## ENVIRONMENTAL RE-EVALUATION CONSULTATION

MTA Long Island Rail Road East Side Access Technical Memorandum No. 6 – 48<sup>th</sup> Street Entrance Design

## REASON FOR RE-EVALUATION

# Figure 1 – 48th Street Entrance – 280 Park Ave (Current Design)

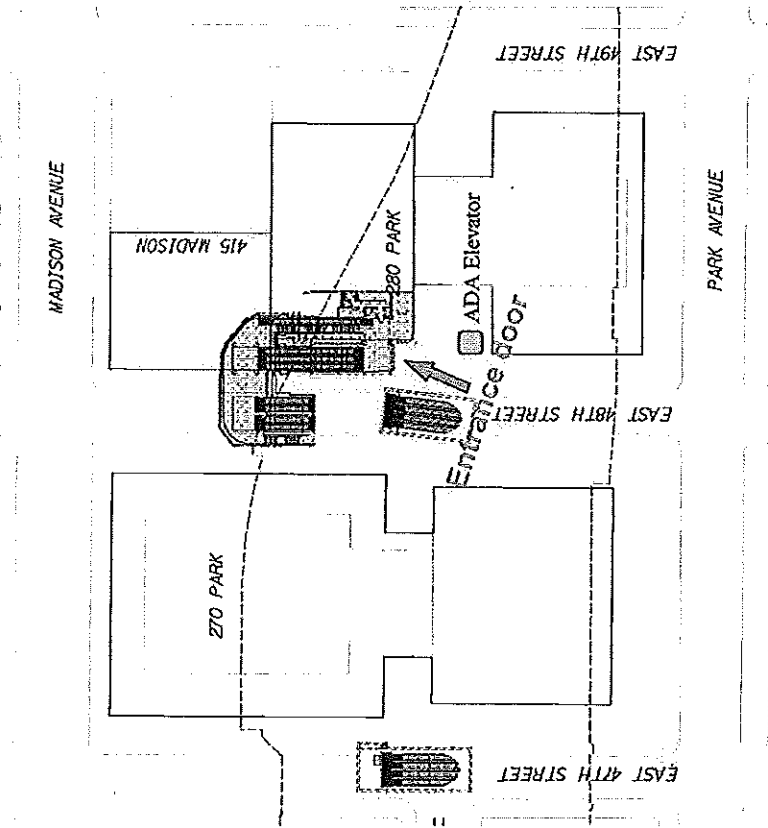
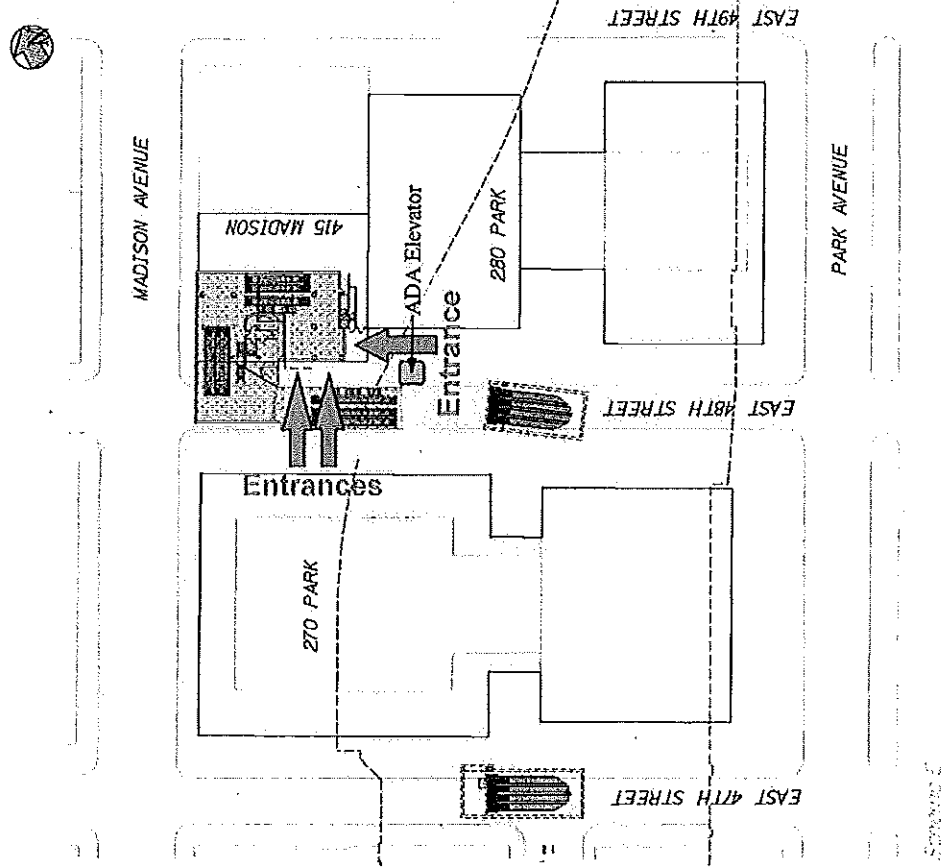
Technical Memorandum No. 6 proposes to move the 280 Park Avenue entrance west to 415 Madison Avenue (an adjacent building) in order to reduce overall construction impact and risk. The shift in entrance location from the Current Design would benefit the construction plan and schedule. The Proposed Design would not cause any significant adverse impacts, nor does it have the potential to cause a change in the determination of impacts from what was described in the FEIS or Technical Memorandum No. 4.

**Entrance Capacity:** The number of escalators and stairs proposed for the 48<sup>th</sup> Street entrance would be reduced from four escalators and one two-lane stair (4+1) to three escalators and one two-lane stair (3+1). The pedestrian flow data indicates that during normal peak period operations, only two peak direction escalators are actually needed to handle the projected passenger flow of 1800 people in the peak 15 minutes. During normal peak operations, no passengers would be required to use the stairway in either direction. A LOS C/D design criteria has been established for the LIRR concourse and the reduced escalator design would meet that criteria. Each escalator processes 70 passengers per minute under LOS C/D conditions. Therefore, the two escalators operating at LOS C/D conditions for the 15 minute period could handle 2,100 customers, several hundred more than the estimated 1800 customers (based on the new LIRR system operating at tunnel capacity and with fully loaded trains). Another design change includes a potential sidewalk bump-out to address concerns expressed by the management of 415 Madison Avenue related to conflicts between new LIRR customers and service deliveries to their building. The sidewalk bump out would be designed in consultation with the New York City Department of Transportation (NYCDOT).

**Utility Relocations:** Under the Current Design, three Con Edison transformer vaults would need to be relocated. Under the Proposed Design the three transformer vaults would not be affected. The Proposed Design also limits the potential impact to building services by reducing building service relocation requirements.

**Geology & Soils:** The Proposed Design significantly reduces the amount of excavation required within 415 Madison Avenue (from 1,460 cubic yards to 390 cubic yards of rock), and eliminates the need for underpinning, transferring column loads, and reframing in both 415 Madison Avenue and 280 Park Avenue. This is because under the Proposed Design, more of the excavation would take place beneath the street and sidewalks (along 48<sup>th</sup> Street and Madison Avenue).

# Figure 2 – 48th Street Entrance – 415 Madison Avenue (Proposed Design)

**Figure 3 – 48th Street Entrance Locations**

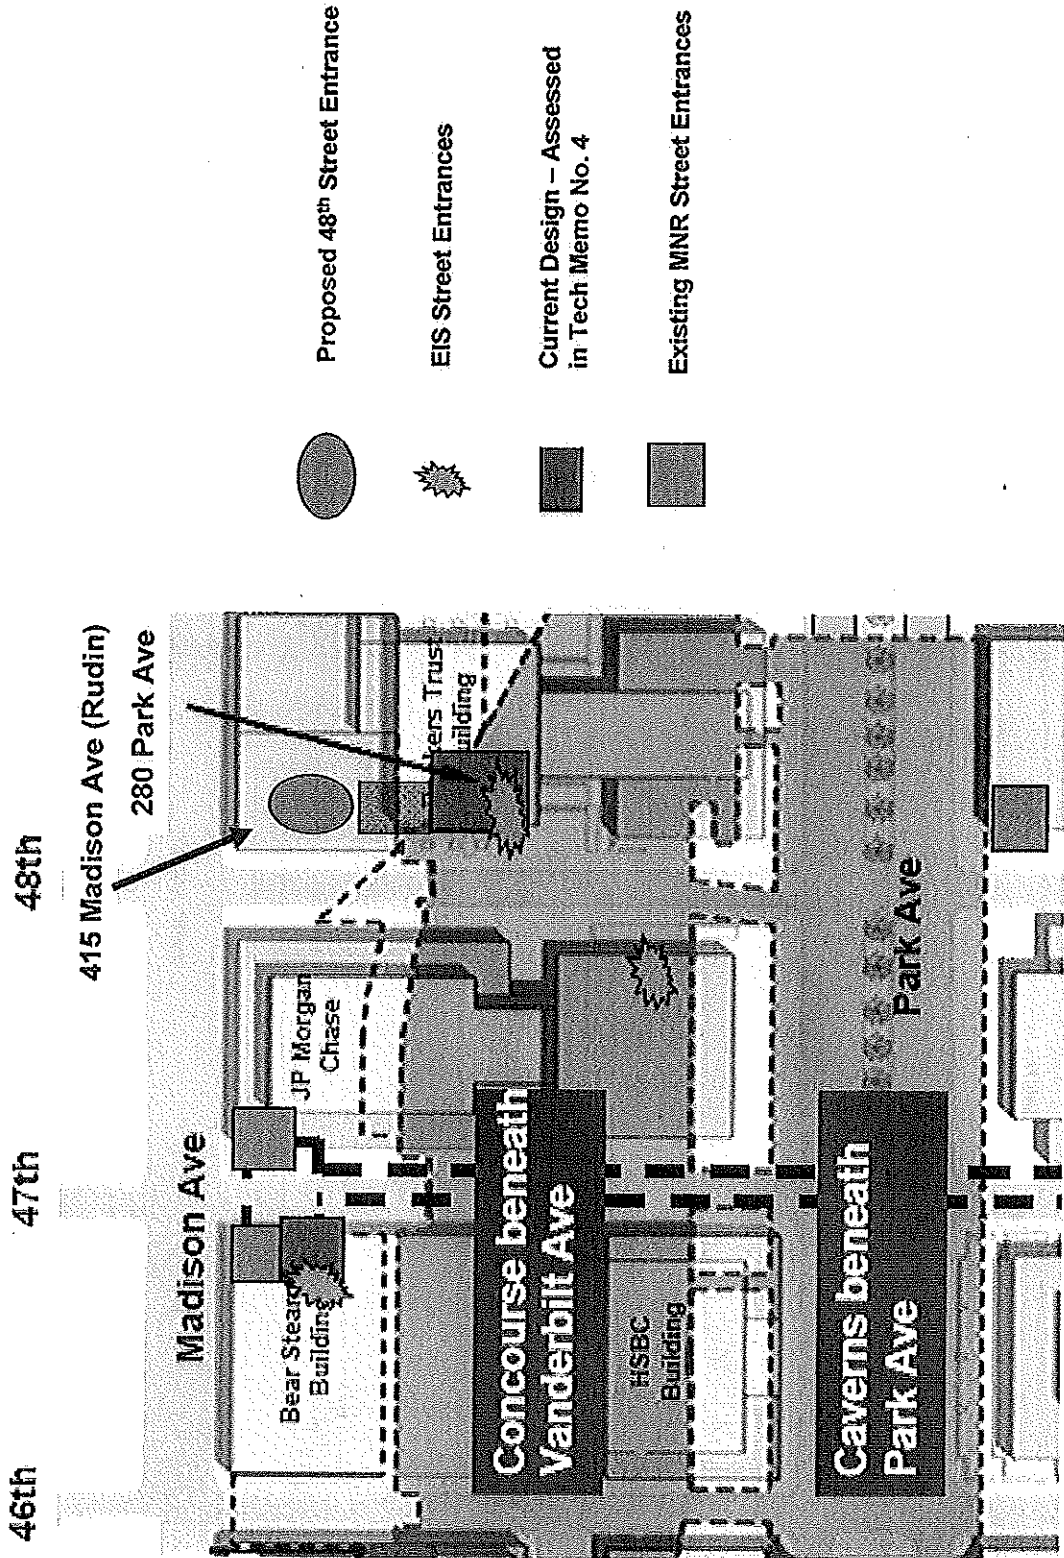
The proposed change would shift the entrance to the west, to 415 Madison Avenue, which is adjacent to 280 Park Avenue (see Figure 3). Note that during the FEIS, it was anticipated that shifts within the same building or block were likely and would not significantly affect the FEIS analyses or conclusions. This assessment confirms that statement.
